New Steering Drag Link Nut (P/N 8M0042636)

Models Covered	Part Number
Mercury/Mariner/Force engines using cable steering systems and 0.375-24 nut	826709113

46950

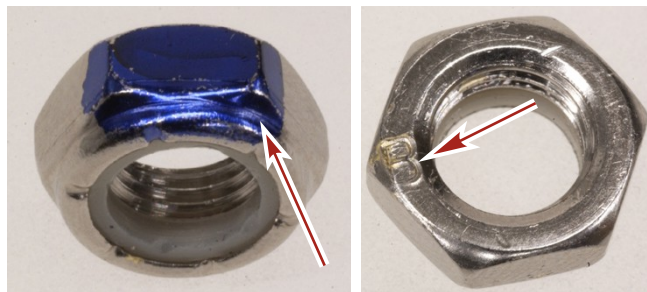
The current stainless steel 0.375-24 nut (P/N 826709113) may have a galling issue during installation to the steering link rod assembly.

A new nut has been developed to eliminate the galling issue.

- Brass 0.375-24 nut (P/N 8M0042636)

The new nut will be nickel plated and will look similar to the stainless steel nut it replaces. The new nut will have a blue marking on one flat of the hex for a limited time in production. After the initial blue identification, a "B" will be stamped on the face of the nut.
